- Subject** ▶ Changes on Handle Spring 62, Upper Handle Base and Lower Handle Base
- For Models** ▶ HR5000, HR5000K (50mm Rotary Hammers)
- Description** ▶ As illustrated below, three parts have been changed to improve endurance of Handle Spring 62.

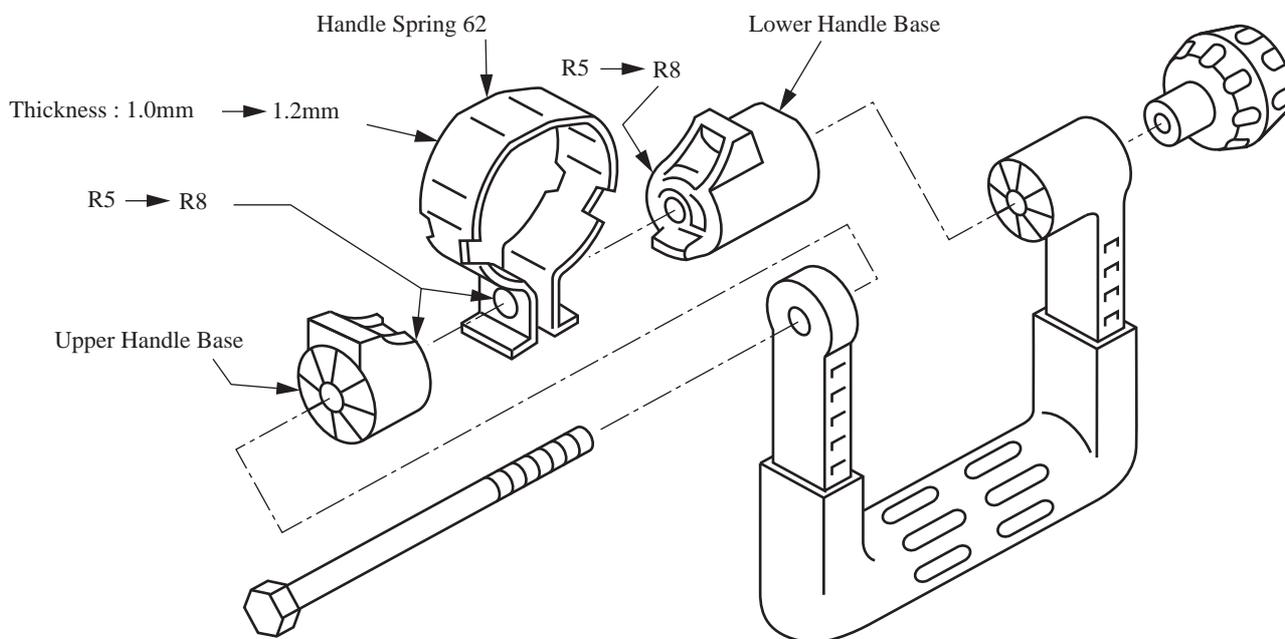
▶ Current	▶ New
Upper Handle Base	Corner contacted with Handle Spring 62 : R5	Corner contacted with Handle Spring 62 : R8
Lower Handle Base		
Handle Spring 62	Corner contacted with handle bases : R5	Corner contacted with handle bases : R8
	Thickness : 1.0mm	Thickness : 1.2mm

Item No.	Current part	Q'ty	I/C	New part	Q'ty	Note
122	Handle Spring 62 344387-3	1	No	Handle Spring 62 344617-2	1	Interchangeable as a set
120	Upper Handle Base 416060-6	1	No	Upper Handle Base 416480-4	1	
121	Lower Handle Base 416089-2	1	No	Lower Handle Base 416481-2	1
